Republik is pleased to present our updated plans for the conversion of the existing Madison Plaza Hotel at 3841 E Washington Avenue into multifamily apartments for final approval with the Urban Design Commission.

Commission Feedback & Repvblik Response:

RENOVATION
PLATO'S MADISON, WI
3841 E WASHINGTON AVE, MADISON, WI 53714

SHEET NUMBER
L-1

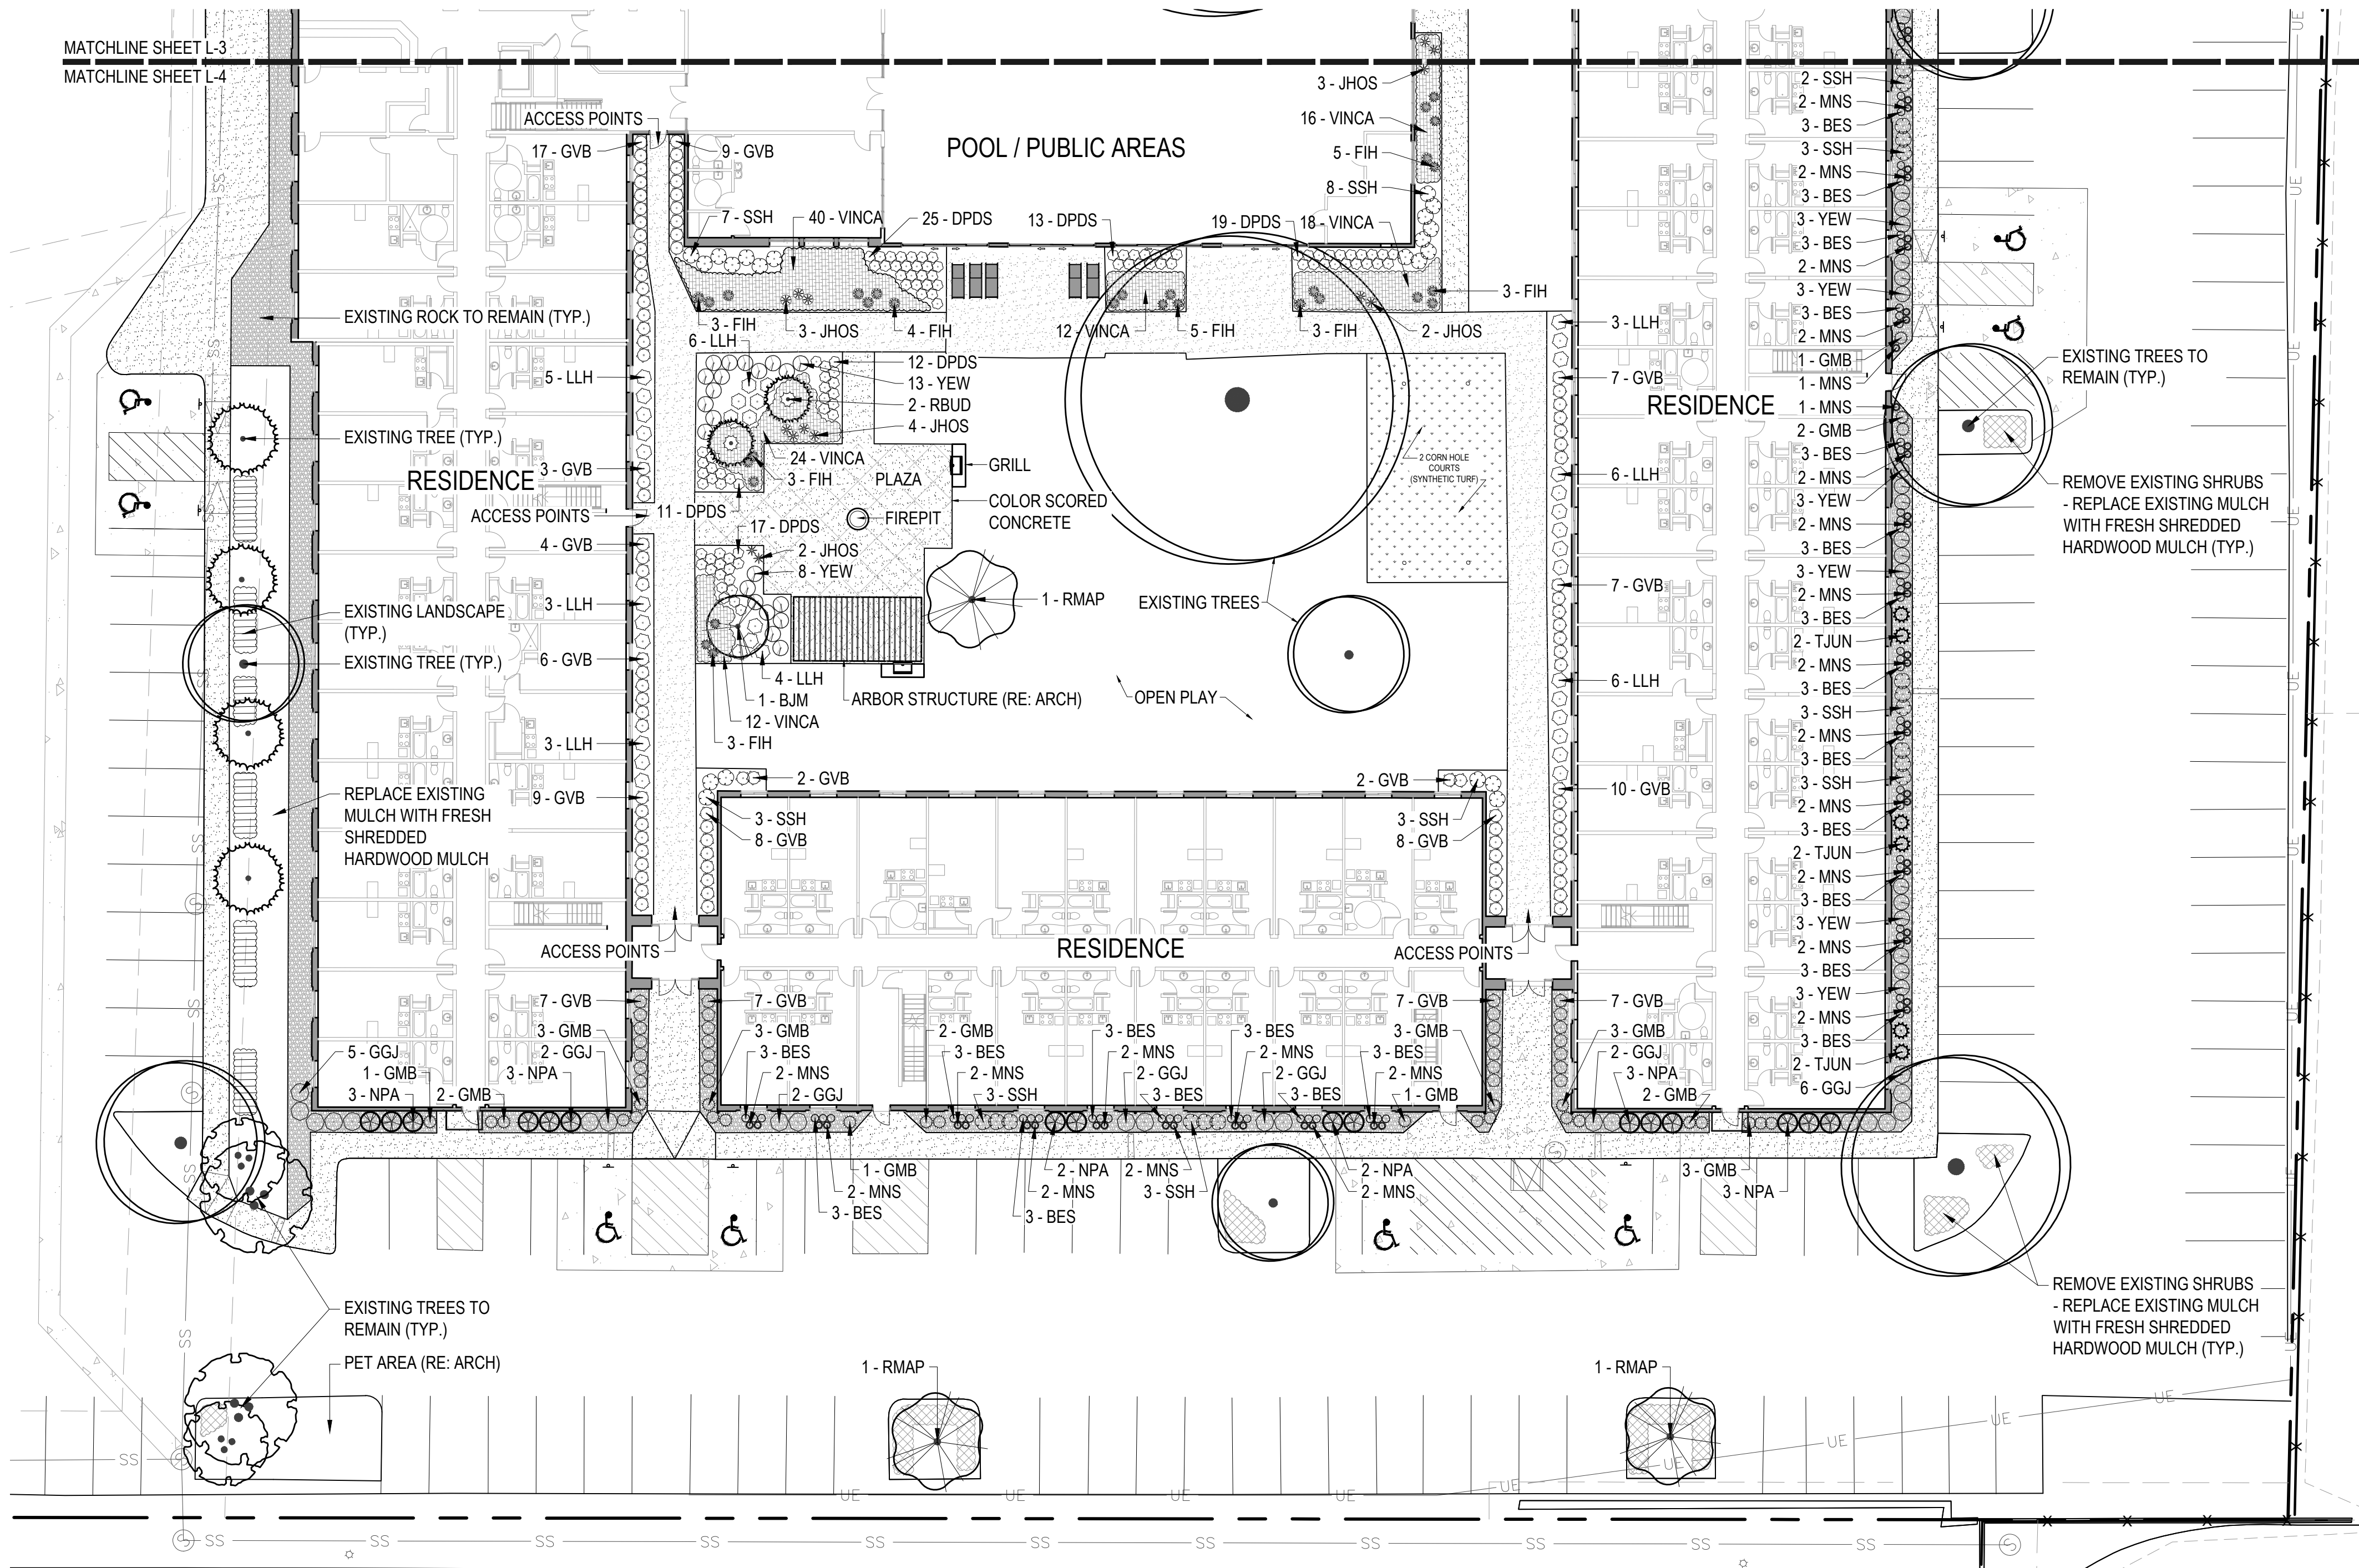
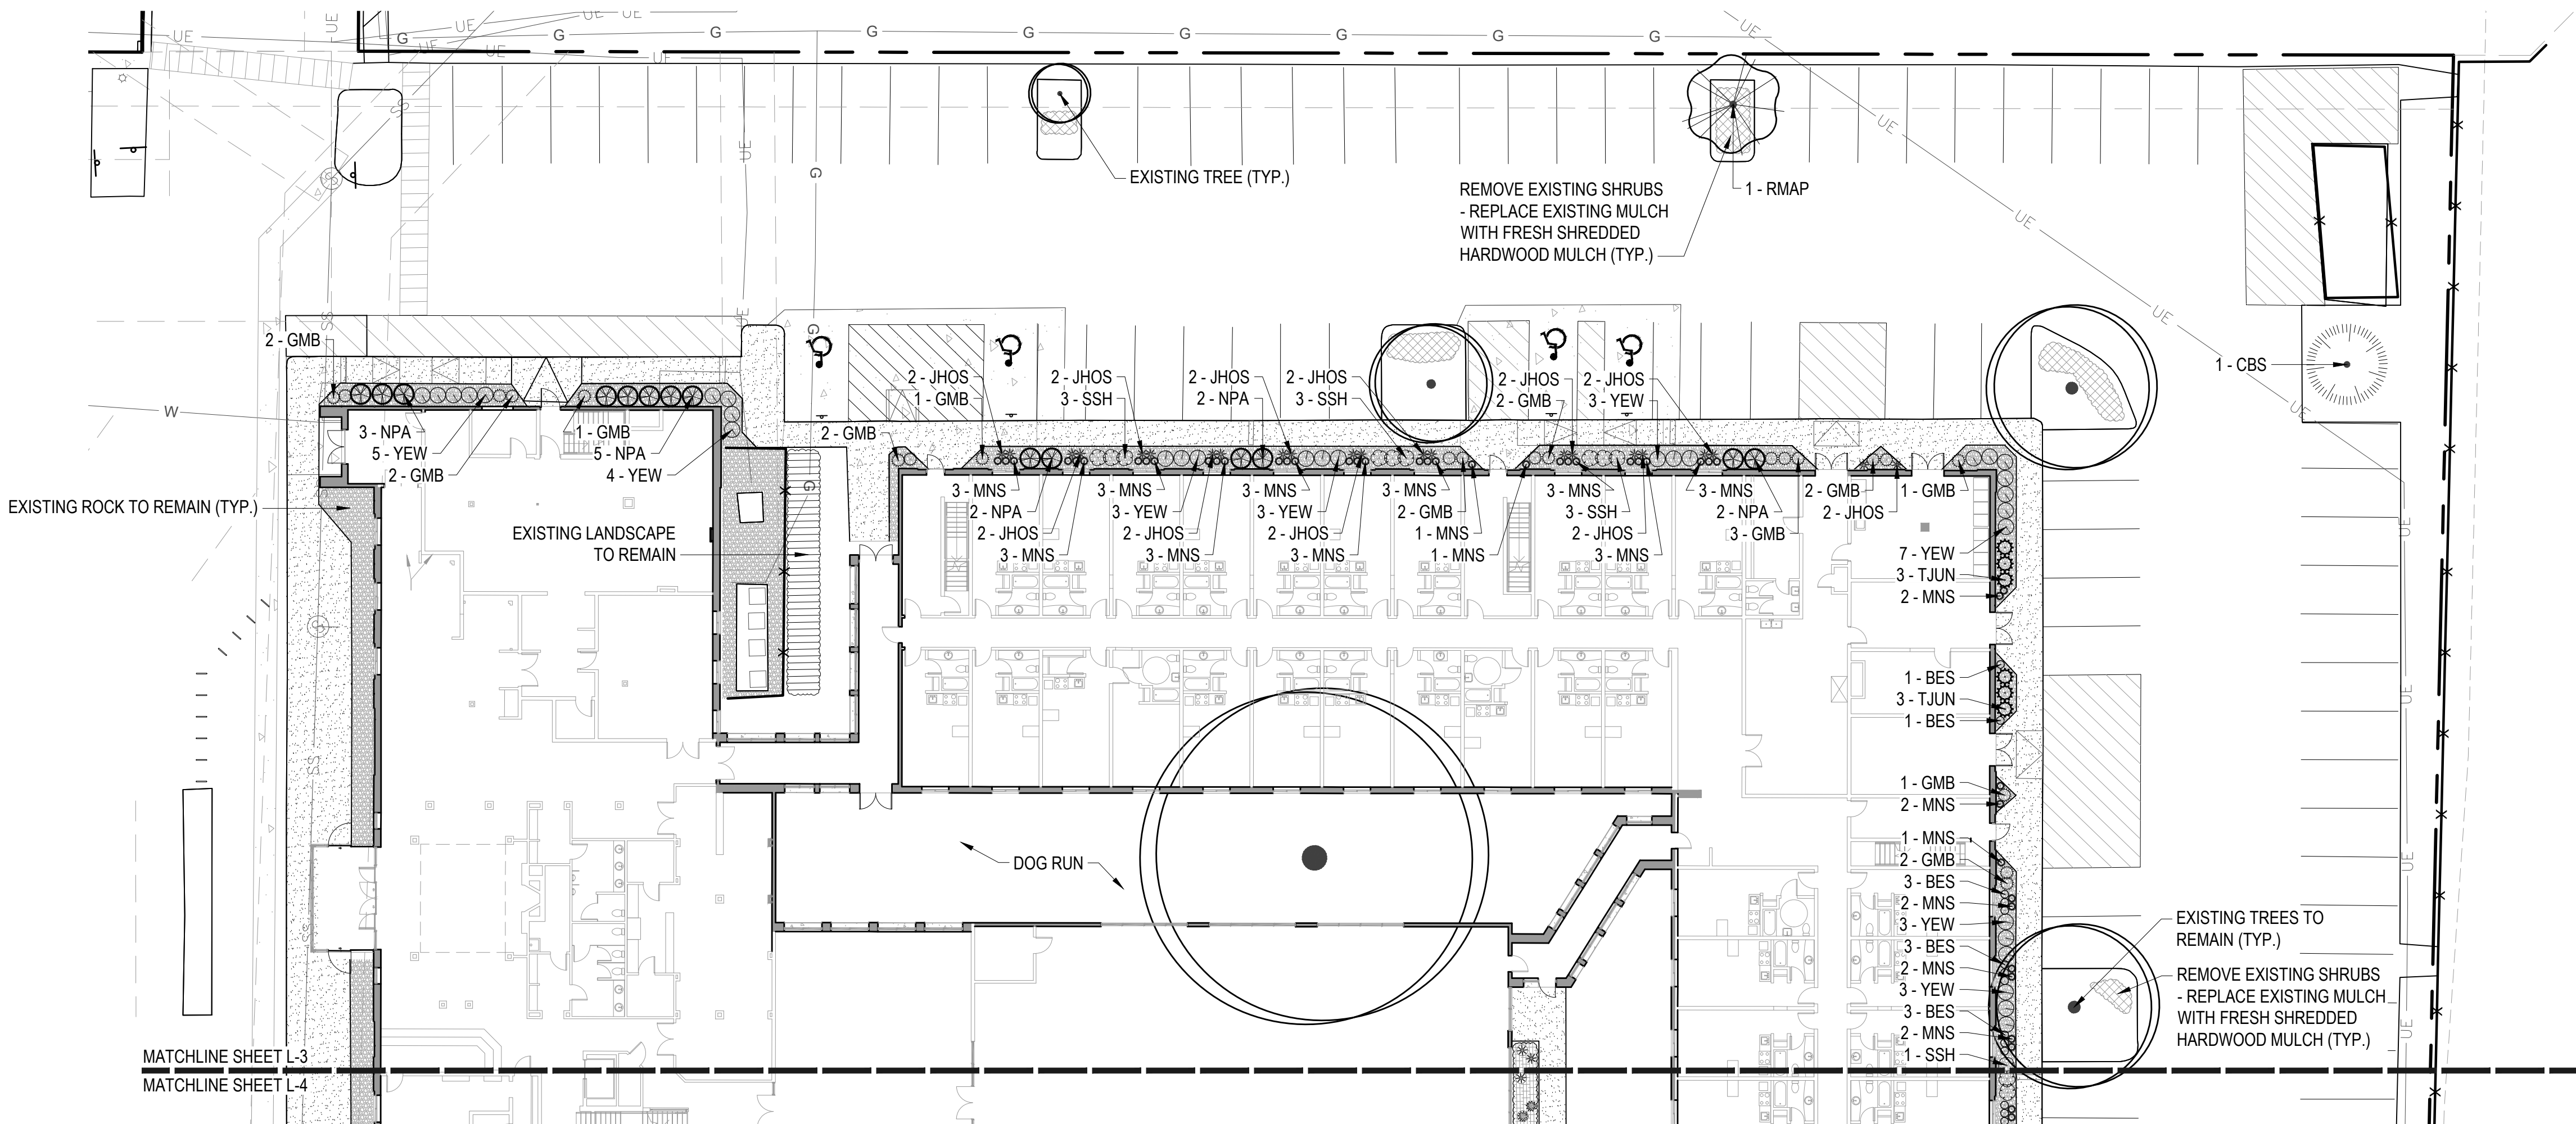
1. The applicant shall provide a landscape plan as part of the Final Approval application, including plantings in the courtyard space and the use of bark mulch.

- a. *A landscape plans are attached herein. We have updated the courtyard landscaping significantly. Where there is exposed earth or mulch beds in the landscape islands around the building, we will enhance the planting in those areas and add fresh bark mulch. This also includes bark mulch in the courtyard space unless directed otherwise.*
